HISTORIC LANDMARK COMMISSION  
STAFF REPORT

**Whittier Project**  
Legalization/Appeal PLNHLC2008-00578  
330 South 1200 East in the University Historic District  
November 5, 2008

The applicant requests that the Historic Landmark Commission legalize changes to a roof form that differ from an approval the Commission granted to a previous owner on August 1, 2001. On April 5, 2005, a request to legalize the work by the last owner of the property was considered by the Commission and denied.

Exhibit G  
Roof plan from building permit #173077

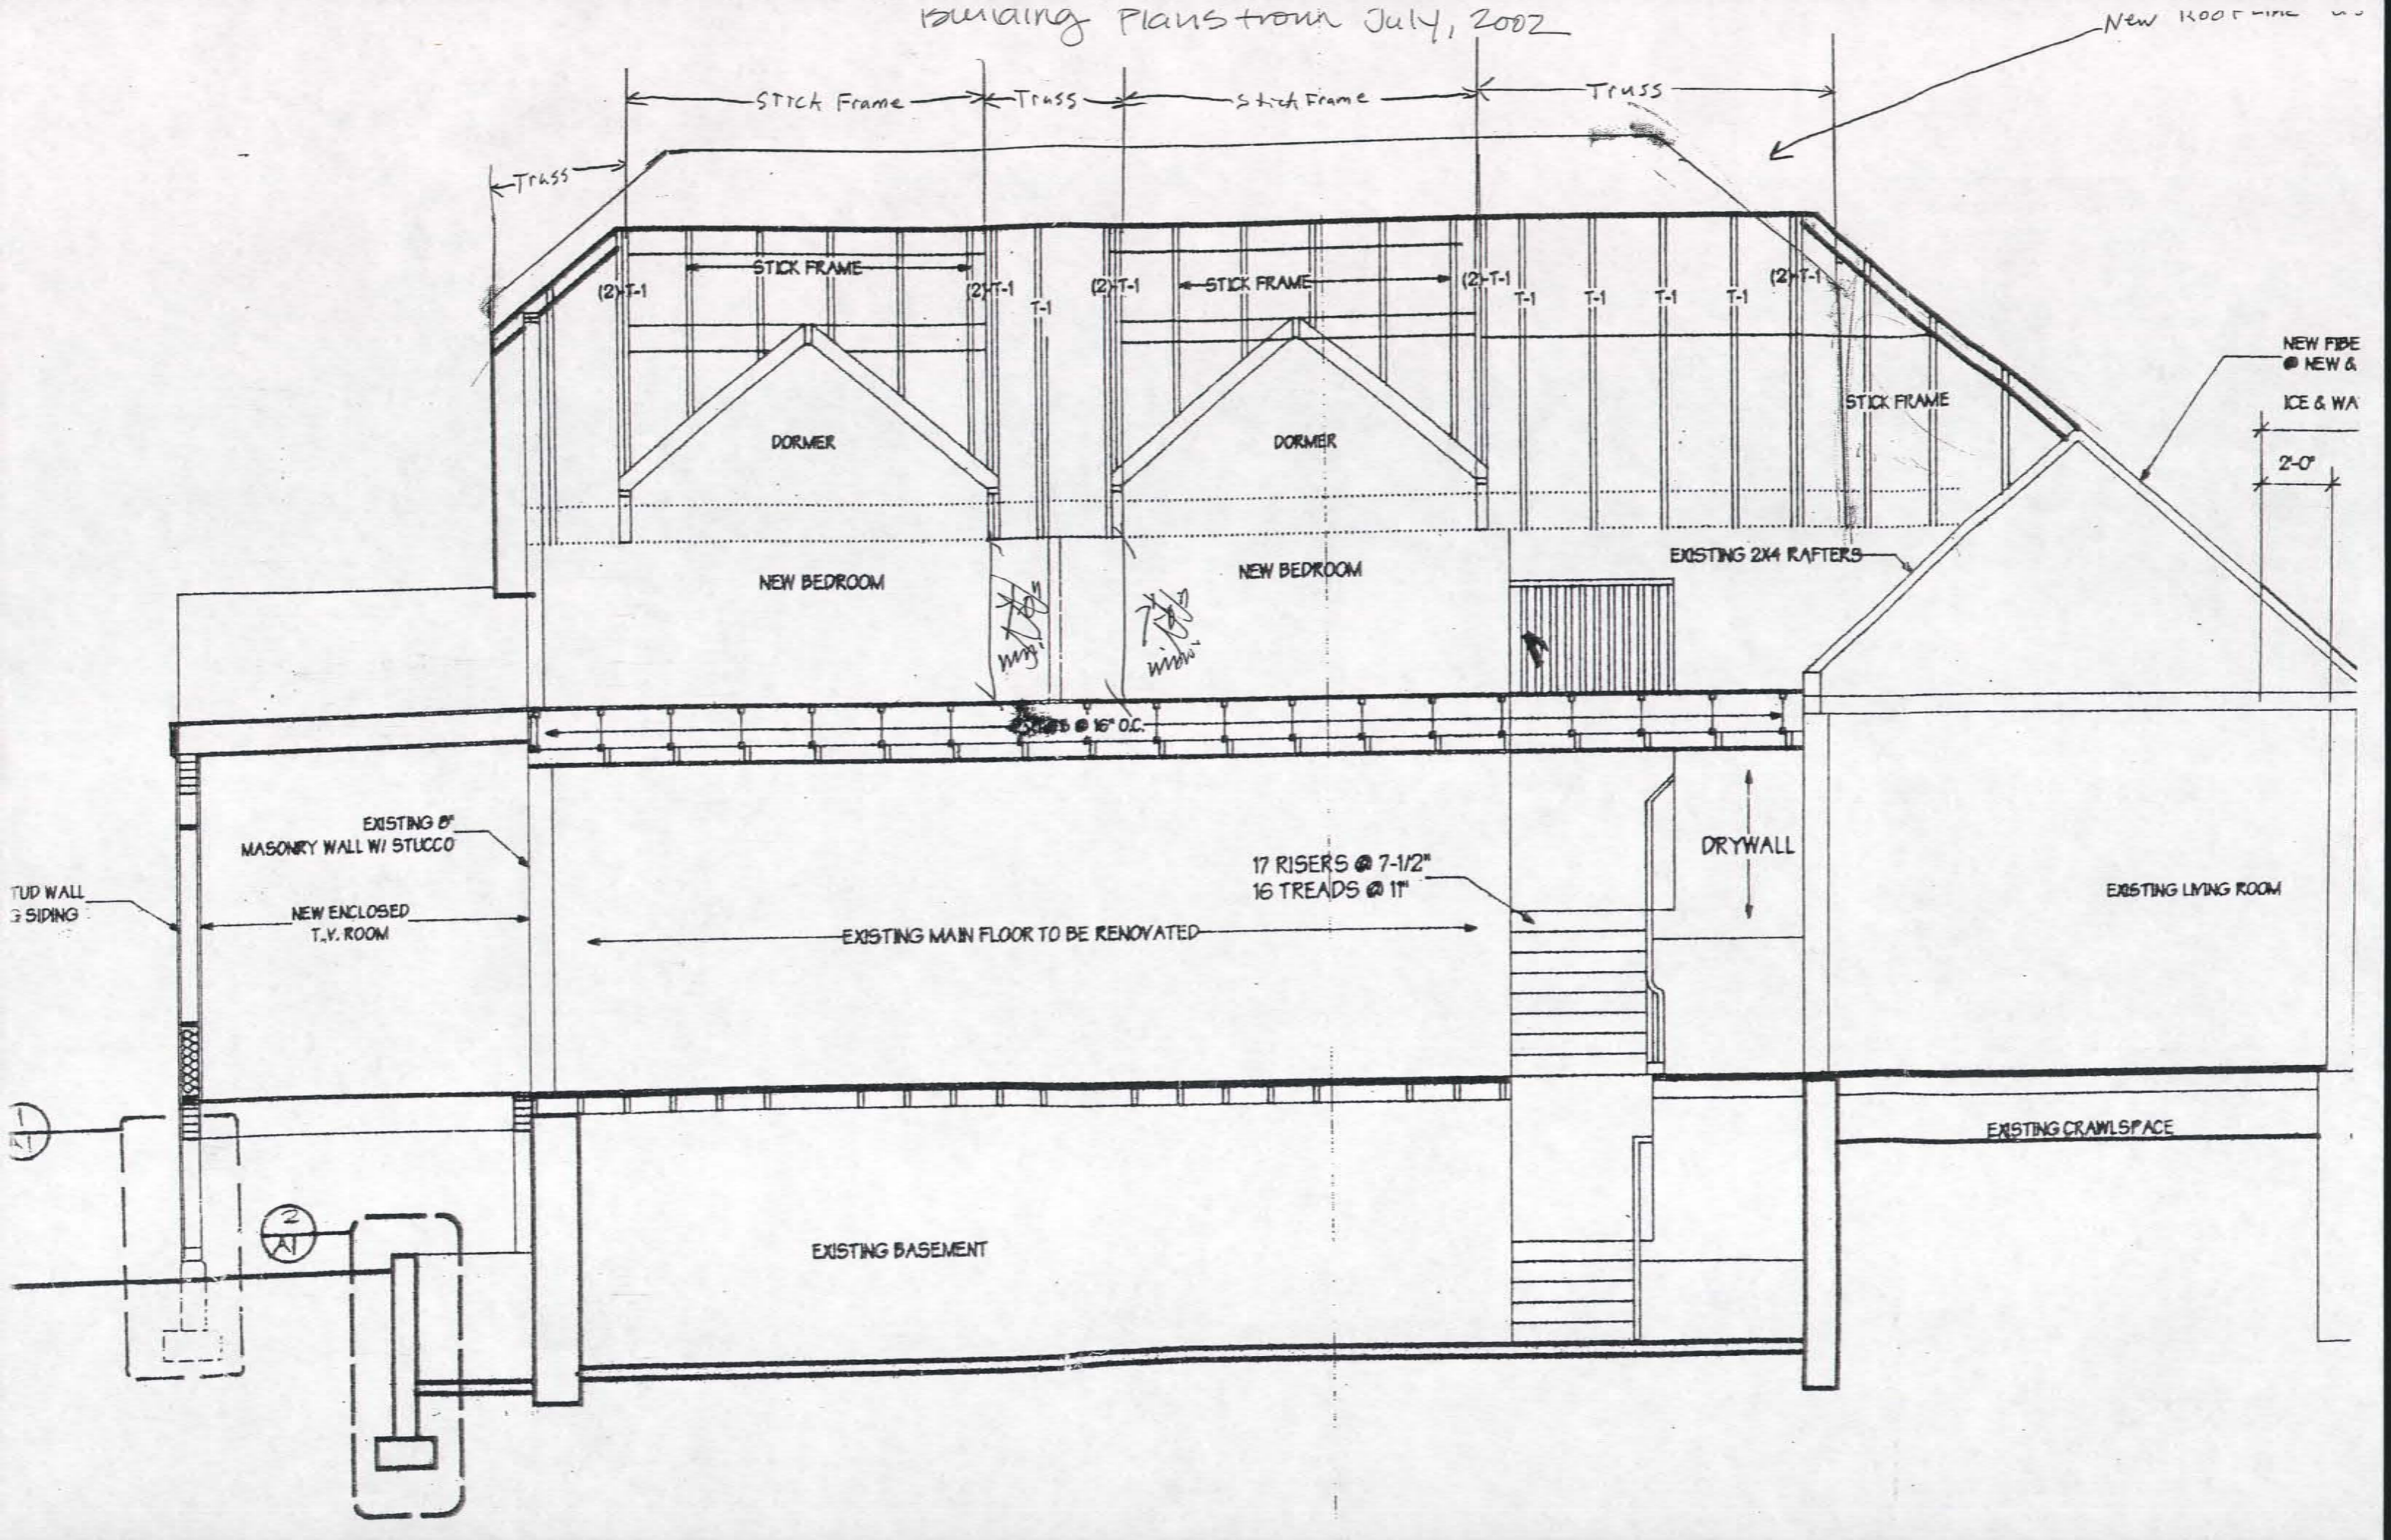
Ms. Hansen obtained a building permit (#173077) on May 21, 2002, after receiving a Certificate of Appropriateness on May 3, 2002. The plans on file in the Building Services Division, the roofline as was approved by the HLC on August 1, 2001. However, these plans show a line drawn from the peak of the roof pitch of the proposed addition to the side-gabled roof of the original house. The existing framing and roofline plans were drawn in between the approval and the submittal of plan to Building Services. (Exhibit G)

| Permit #<br>173077 | 5/21/02 | Addition and remodel; historic approved window sheet only.   | On these plans, the roofline is shown as HLC approved on 8/1/01. Nelson believes (from 8/19/04) conversation that existing framing and roofline was drawn in between HLC sign off and submittal of plans. Both rooflines are apparent. These plans also do not show the upper story living space under the east slope of the roof. |          |

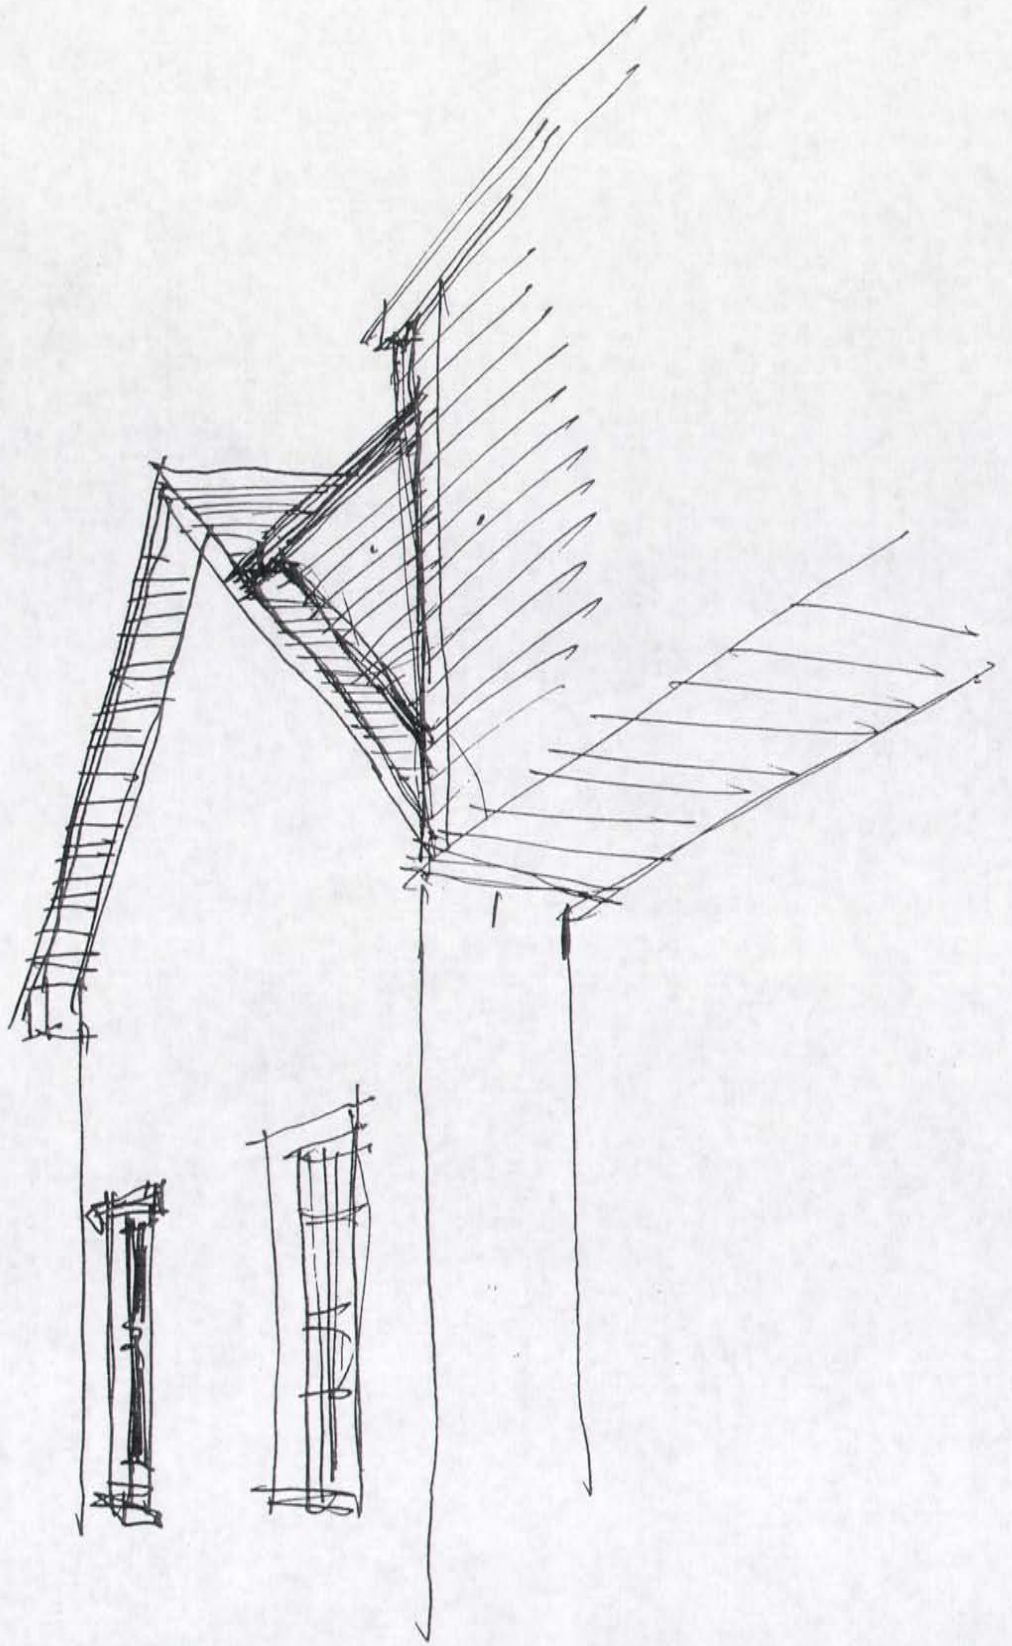
*material on additions?*

*put siding in gable end? - match the addition below.*

*wrap posts w/ lx trim - beads up*

*connection between <sup>gable</sup> front of bldg. and 2<sup>nd</sup> floor of addition.*

**SOUTH ELEVATION**  
SCALE 1/4"=1'-0"

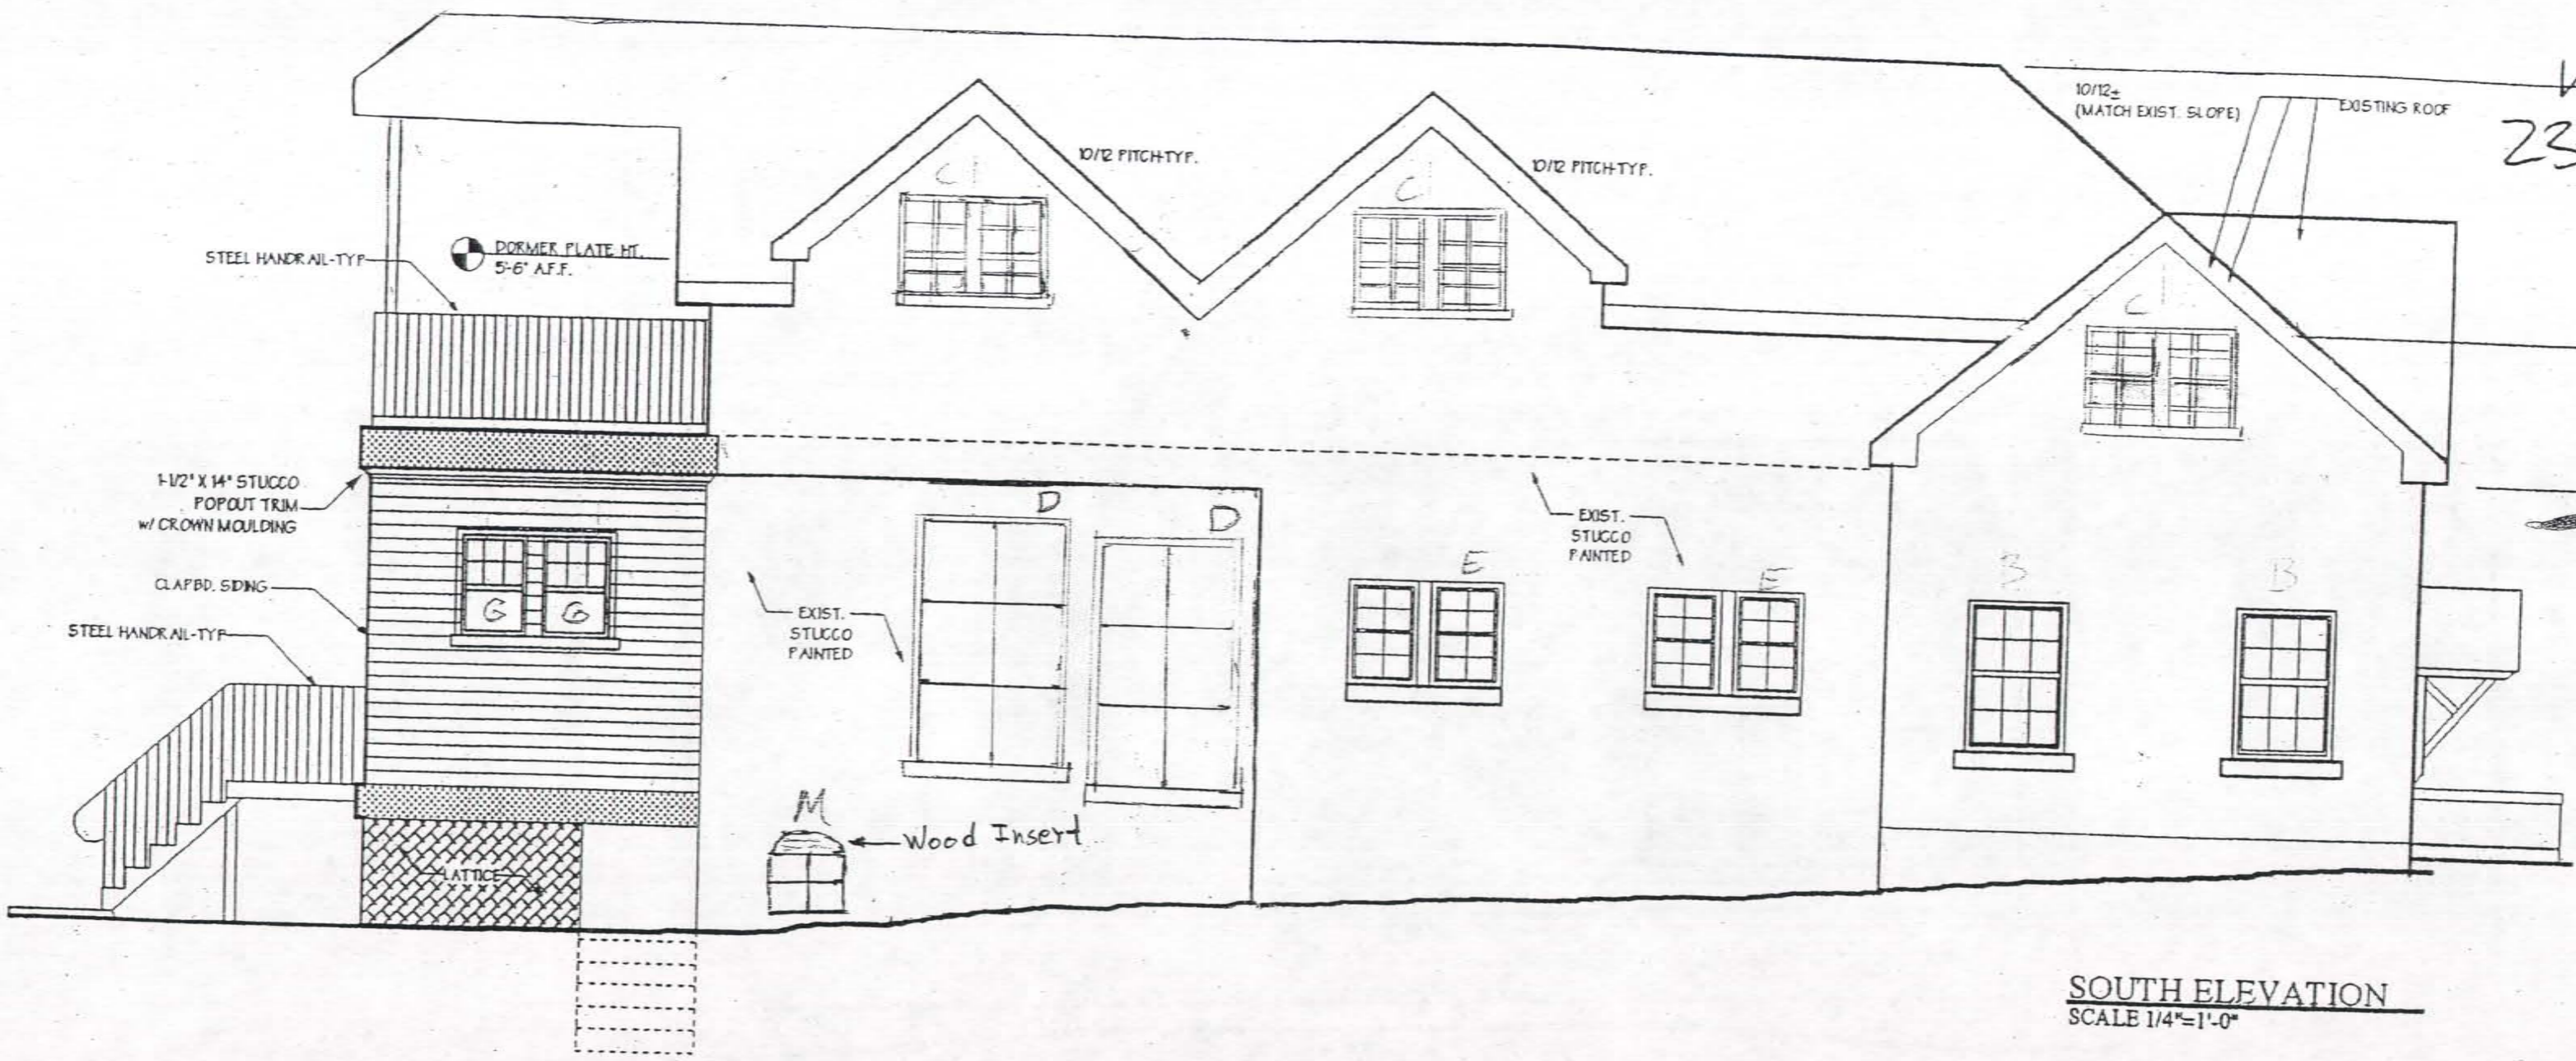
Staff's finding of fact: The applicant is willing to undo the previous window deviations from the original plans. Pending improved graphic representation of the windows elevations, staff finds that the applicant meets this standard, with the exception of the large windows on the south elevation noted as "D."

**FINDING:** The applicant is willing to undo the previous window deviations from the original plans. Pending improved graphic representation of the windows elevations, staff finds that the applicant meets this standard, with the exception of the large windows on the south elevation noted as "D."
